CITY OF VANCOUVER

POLICY REPORT DEVELOPMENT AND BUILDING

SUBJECT: SEFC ODP and CD-1 By-law Text Amendments for 140 W 1st Avenue
(formerly 102-160 W 1st Avenue)

Figure 1: SEFC ODP Maximum Heights

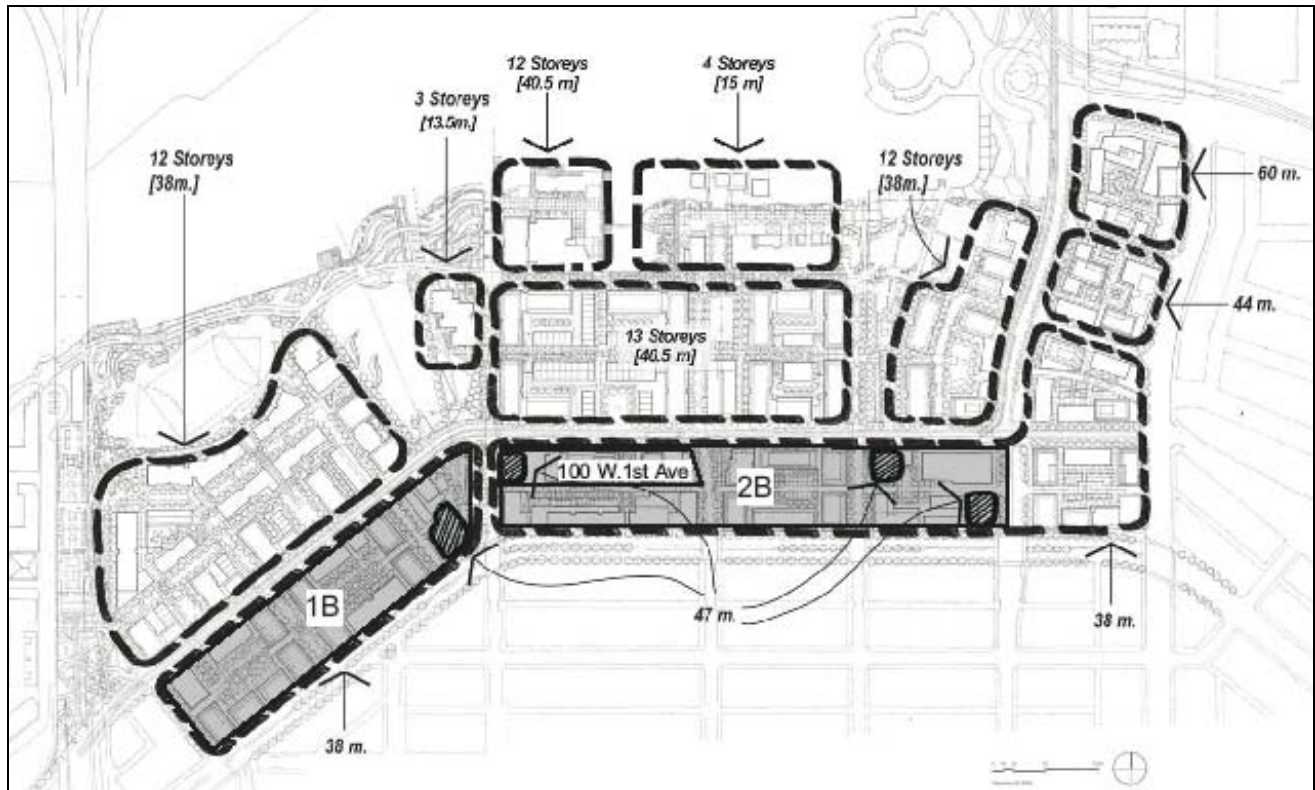
The SEFC ODP maximum allowable building height for Sub Areas 1B and 2B is generally 38 m, with a few exceptions for higher building forms at a maximum height of 47 m to define landmark locations (see: Figure 1).

Figure 2: Proposed Heights for 100 West 1st Avenue

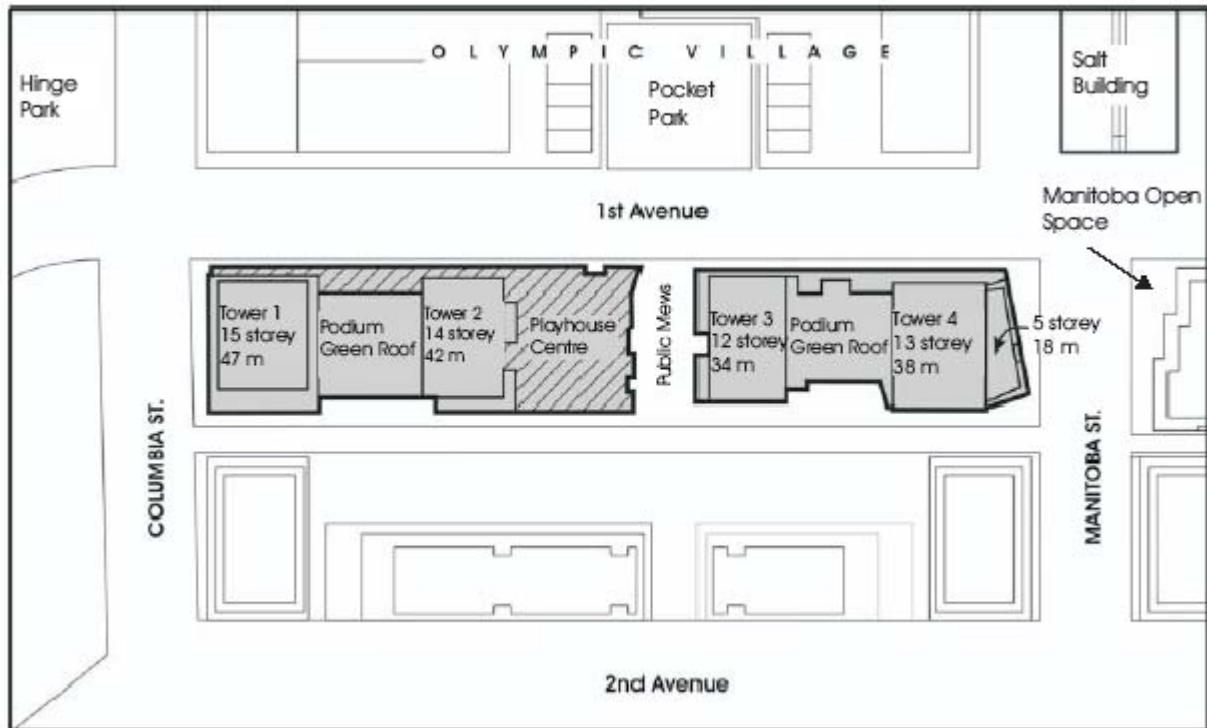
In their ODP Text Amendment application and Development Application, GBL Architects have proposed a height increase from 38 m to 42 m for Tower 2 (see Figure 2). This would result in 4 m of additional height above the current allowable ODP height. Tower 3 (see Figure 2) has also been increased by one storey (4 m) however the height falls within the 38 M height limit of the ODP, and therefore does not require an ODP text amendment.

The proposed increases in height are accompanied by reductions in height on other buildings. The height of the podium between Towers 3 and 4 has been reduced by one storey (2.6 m) and the shoulder massing of Tower 4 has been reduced by two storeys (5.6 m).

First Avenue Elevation

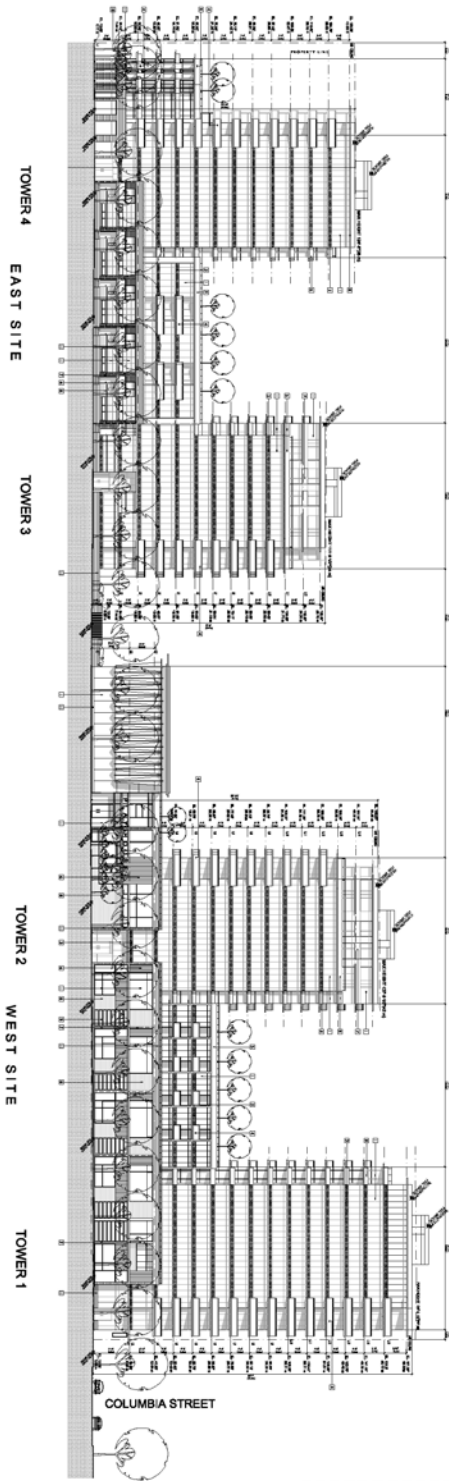
Several Panel members didn't think the approach to passive design was very strong and suggested increasing the solar performance of the south and west façades by further extending the proposed architectural projections or reducing the percentage of glazed openings. Also the Panel suggested increasing the size of the west facing balconies to achieve greater solar shading. One panel member recommended for this project, that the City relax the maximum 8% balcony FSR exclusion in order to achieve a greater environmental benefit.

The Panel felt the project would fit well into SEFC although one member thought it wasn't as successful as other projects in the area. Generally, the panel thought the expression of the four towers was too uniform and monotonous, and could be more distinctive. One panel member suggested using more depth and layers in the facade treatment to create a stronger architectural expression. The panel thought the two storey base expression was more successful than the towers above. One panel member thought the retail expression on Manitoba Street could be stronger, with the project's typical two story base expression continuing along Manitoba Street.
